MAINE YANKEE ATOMIC POWER COMPANY •  
ENGINEERING OFFICE

November 20, 1979

Subject: NRC Requirements for Auxiliary Feedwater Systems at the  
Maine Yankee Atomic Power Station

ENCLOSURE 1X.4.3.1 SHORT TERM RECOMMENDATIONS

Auxiliary Feedwater System  
Main Yankee

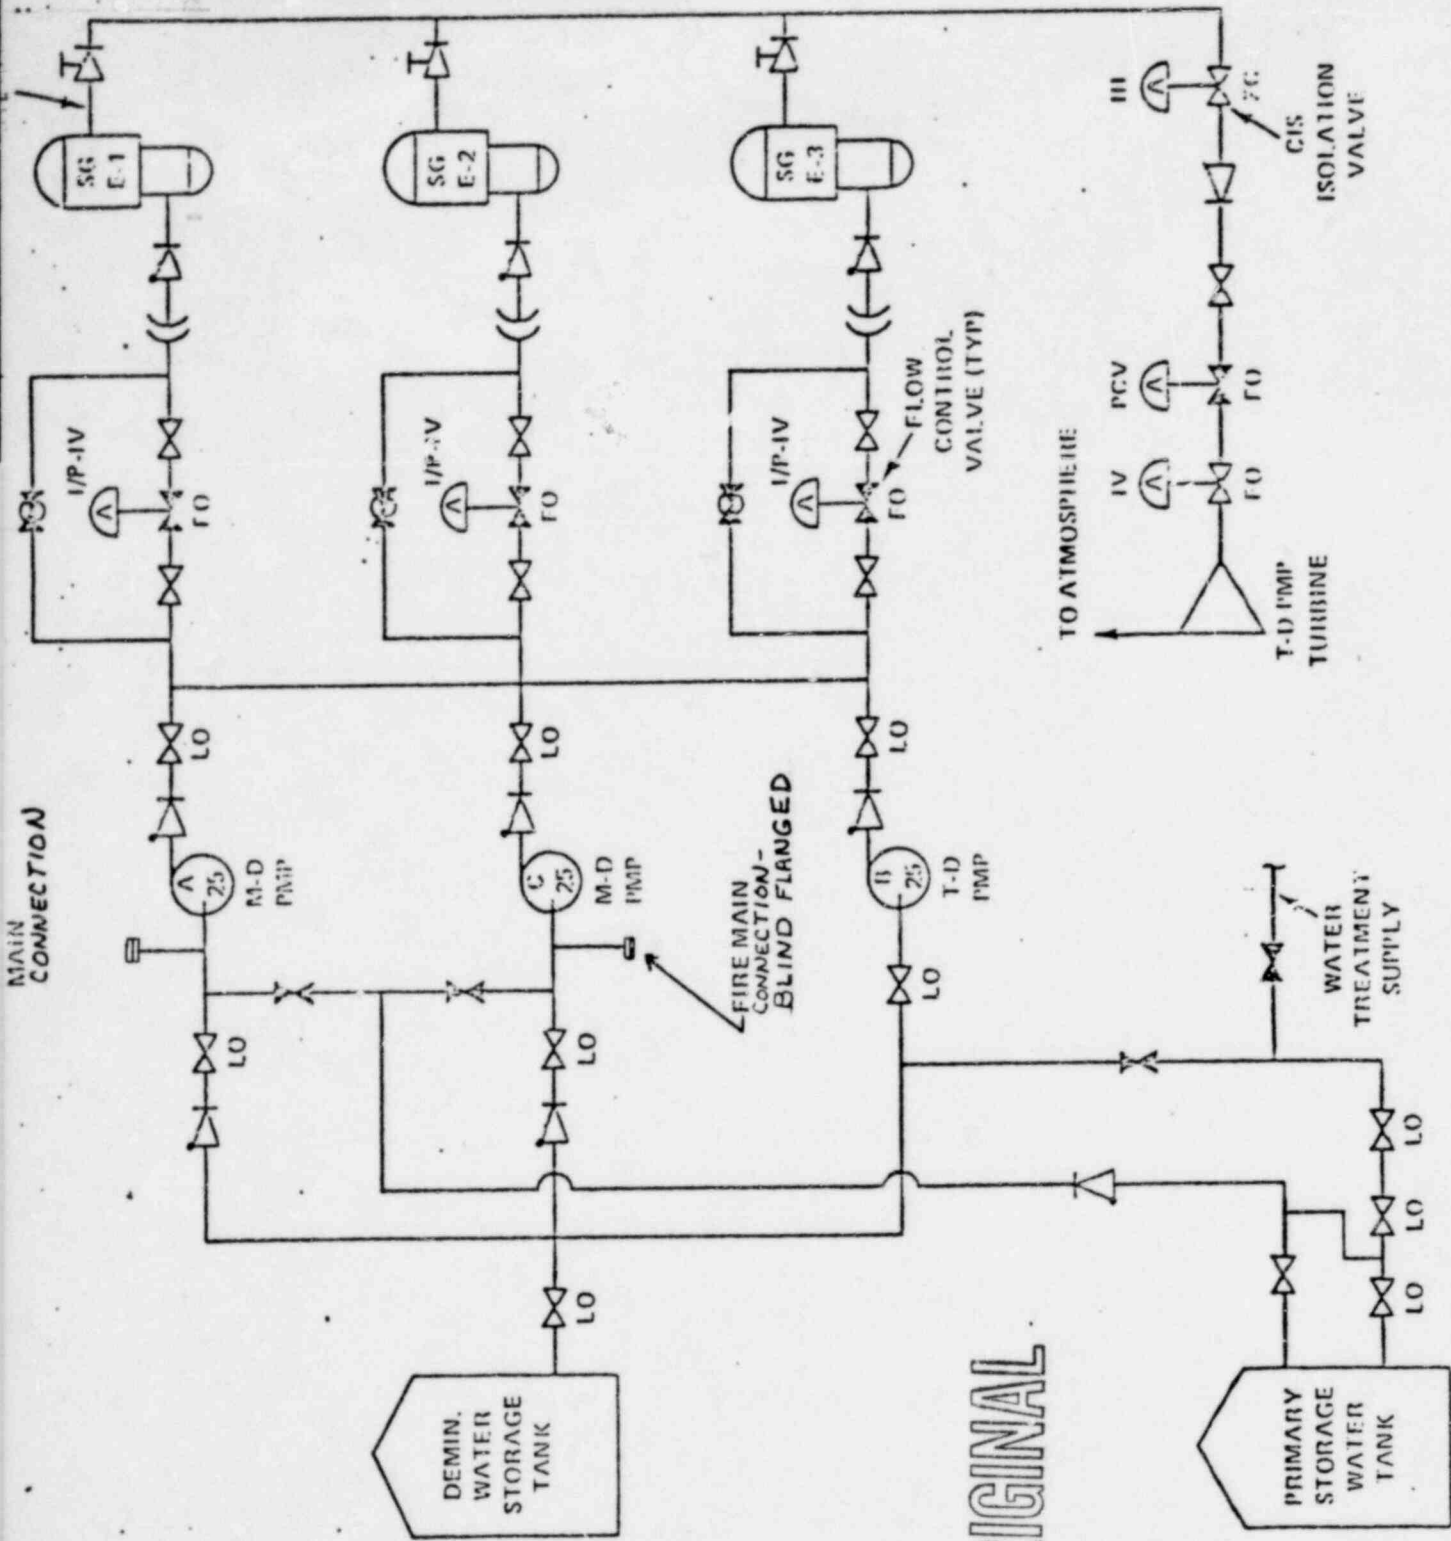
The attached sketch submitted in Enclosure 1 of Reference (b), has been revised by Maine Yankee to reflect actual systems configuration.
